RED BARN MACHINE		REV
TITLE		TITLE
TAIL ROTOR PITCH CHANGE HOUSING		DUPLEX BEARING REMOVAL
DWG NO.		RBW109-3130-70-101
MATL	DRAWN BY:	GILBERT
UNLESS OTHERWISE SPECIFIED	APPROVED	D Weil
DIMENSIONS ARE IN INCHES		
.XXX ± .005	FRACTIONS ± 1/32	HEAT
.XX ± .01	ANGLES ± .5°	TREAT
.X ± .1		FINISH
1. BREAK ALL SHARP EDGES .015 X 45°	SPEC	
OR .015R	USED ON MODEL	
2. DIMENSIONAL LIMITS APPLY AFTER		
PLATING	AW109	
SCALE	1:2	DATE
		4/5/2011
		SHEET 1 OF 5

PIN

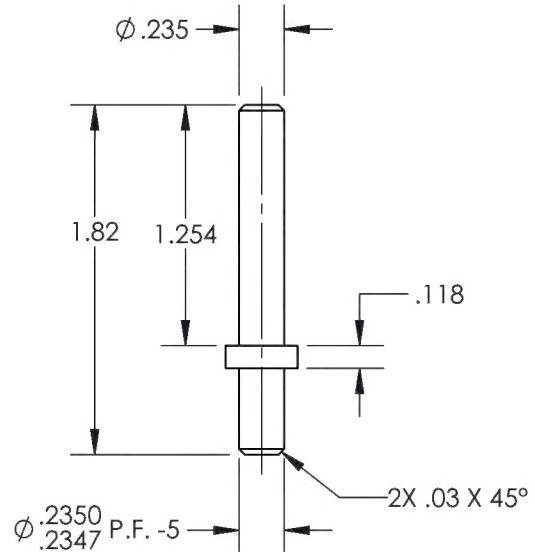
REVISIONS				
REV	DESCRIPTION	DATE	INITIAL	APPROVED
1	-3 ADDED .03 X 45° CHAMFER TO PRESS FIT PIN.	10/17/2013	CFS	RW
2	-3 CH'D DIM WAS 1.260 IS 1.254, WAS .115 IS .118. ADDED CHAMFER WAS .03 X 45° IS 2X .03 X 45°.	4/17/2014	RJC	DW

BARREL

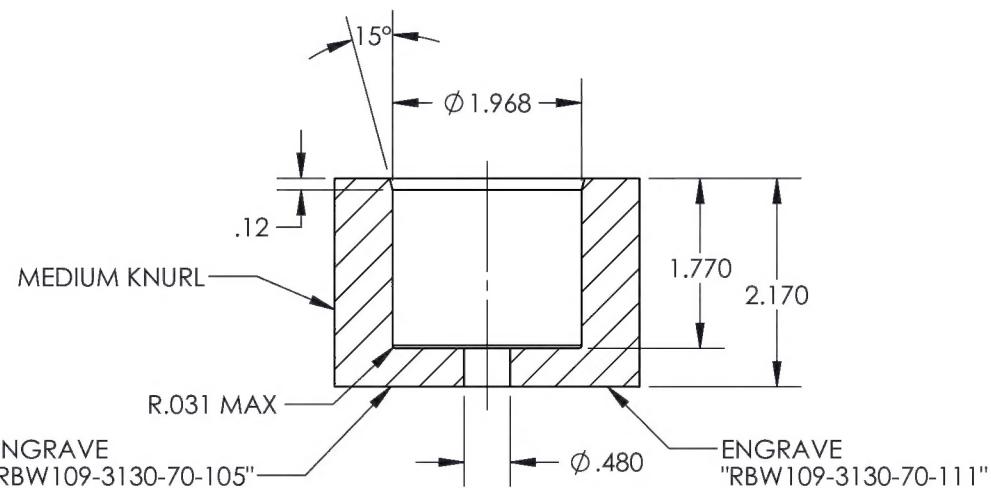
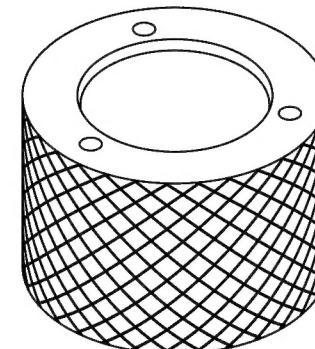
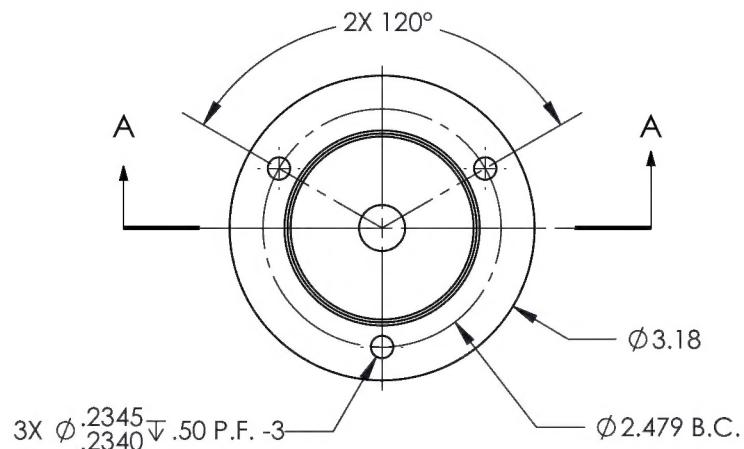
REVISIONS				
REV	DESCRIPTION	DATE	INITIAL	APPROVED
2	-5 CH'D BOLT CIRCLE WAS Ø2.382 IS 2.479, ADDED .12 X 15° CHAMFER, ADDED R.031 MAX, ADDED ENGRAVE "RBW109-3130-70-111".	4/17/2014	RJC	DW

BASE

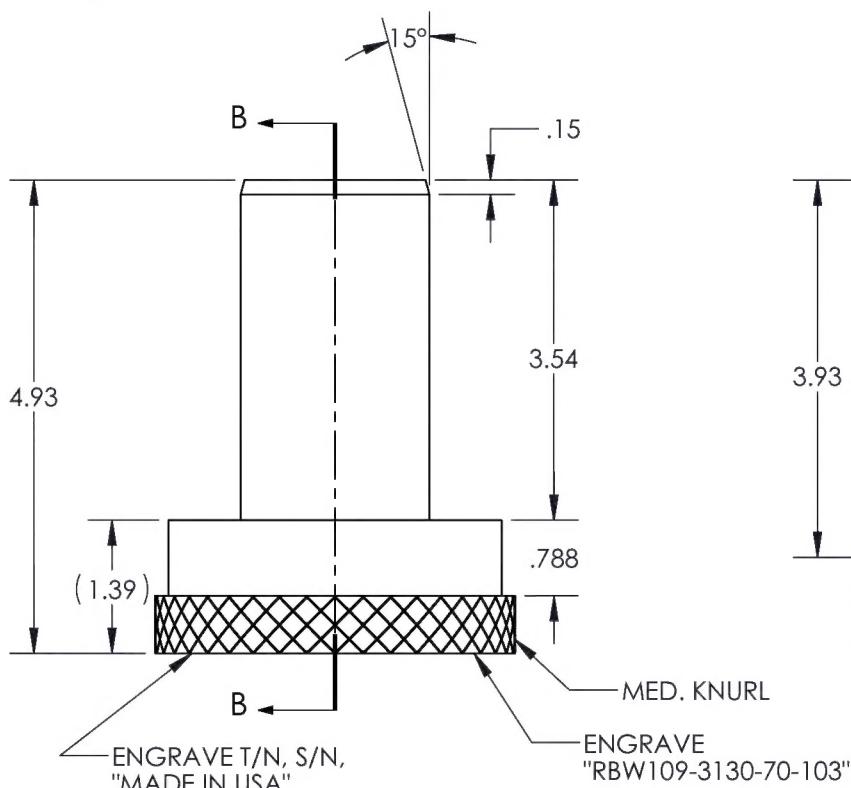
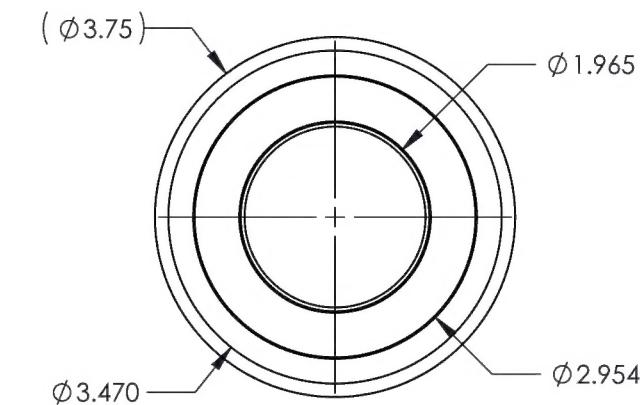
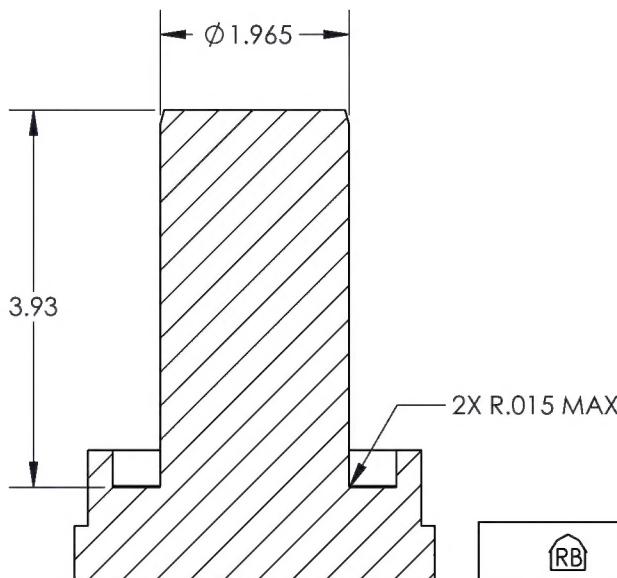
REVISONS				
REV	DESCRIPTION	DATE	INITIAL	APPROVED
2	-7 CH'D CHAMFER WAS .15 X 30° IS .15 X 15°, CH'D DIM'S WAS 3.93 IS 4.93, WAS 2.925 IS 3.93, WAS 2.515 IS 3.54, WAS Ø2.95 IS 2.954. ADDED 2X R.015 MAX.	4/17/2014	RJC	DW
